THIS IS FOR THE PURPOSE OF SECTION 4.55 APPLICATION TO COUNCIL ONLY

SECTION 4.55 ISSUE: FF'S FACADE MATERIAL UPDATED. LOWER SECTION OF KITCHEN'S SOUTHERN FACADE UPDATED.

41 & 43 BEACH ROAD COLLAROY
LO1 1 DP300846 AND LOT 2 SEC 7 DP7391

PROJECT		DATE	REVISION NUMBER:
41 & 43 BEACH ROAD COLLARROY LO1 1 DP300846 AND LOT 2 SEC 7 DP7391		16/03/2022	A
DRAWING TITLE	SCALE	DRAWING NO.	
MATERIALS AND FINISHES SCHEDULE	N/A	S4.55 400

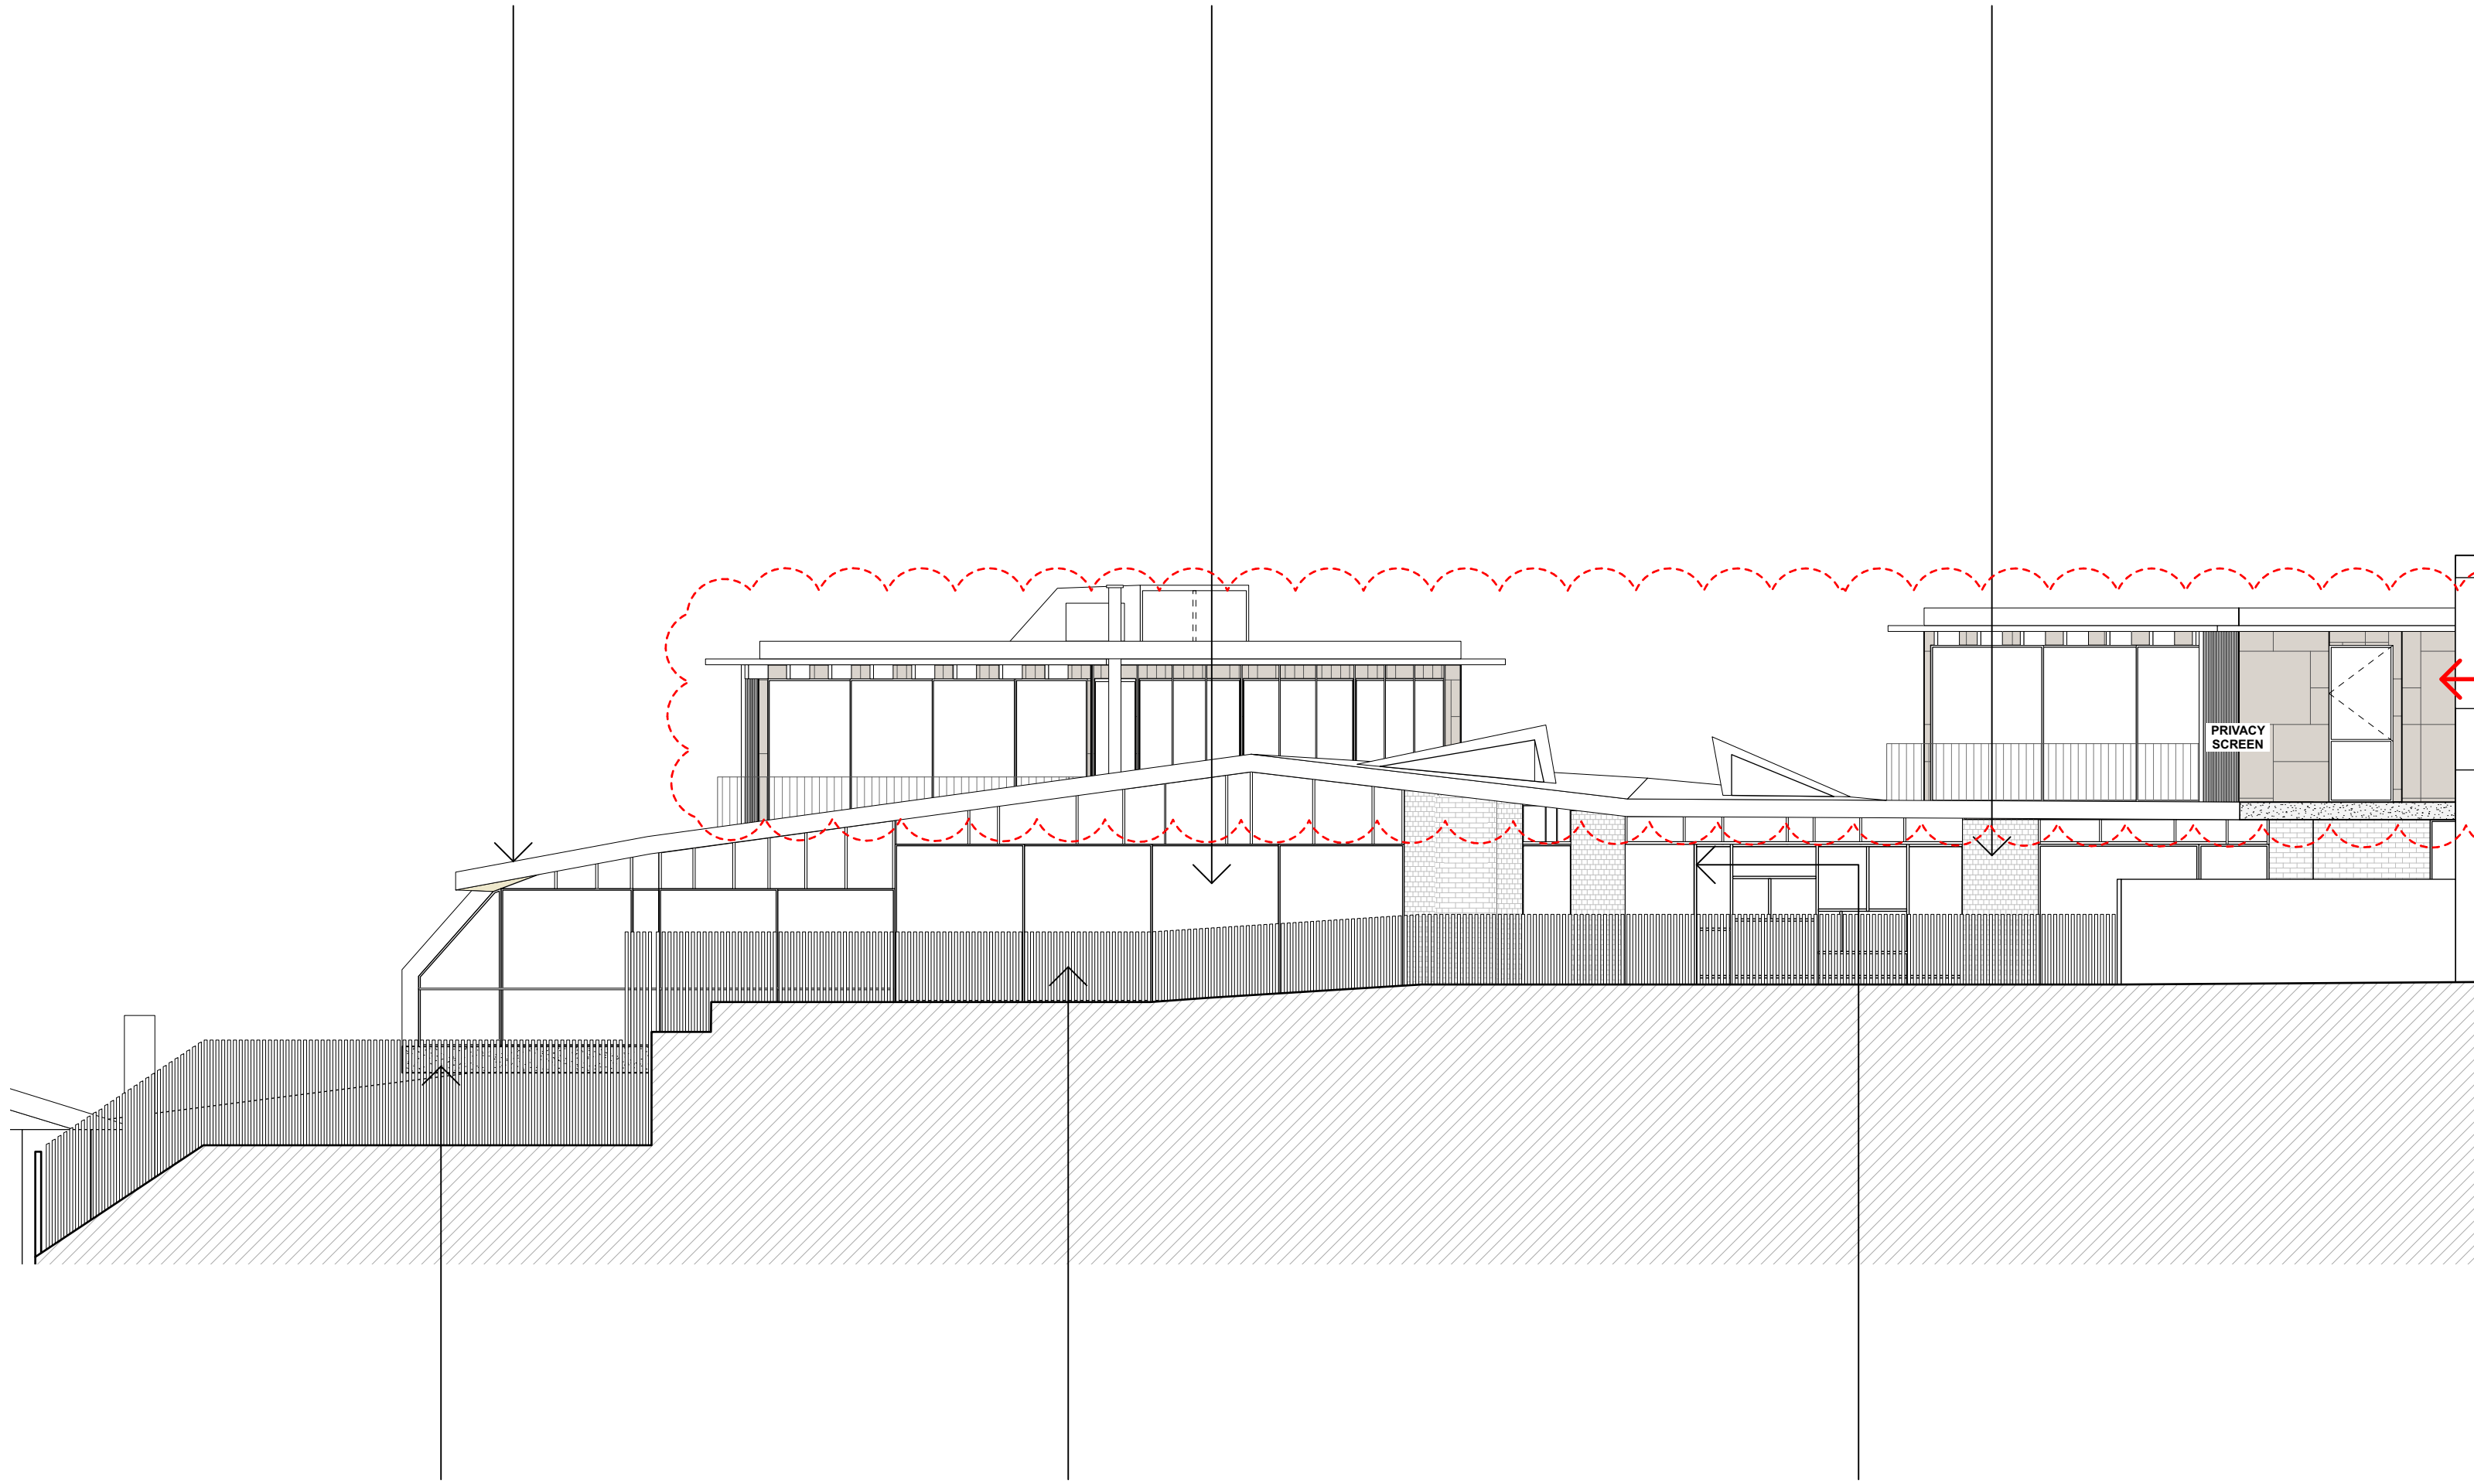
SECTION 4.55 APPLICATION AMENDMENT - SHOWN CLOUDED IN RED:
FF'S FACADE UPDATED
FLATLOCK ALUMINIUM CLADDING - GREY COLOUR - MATT FINISH
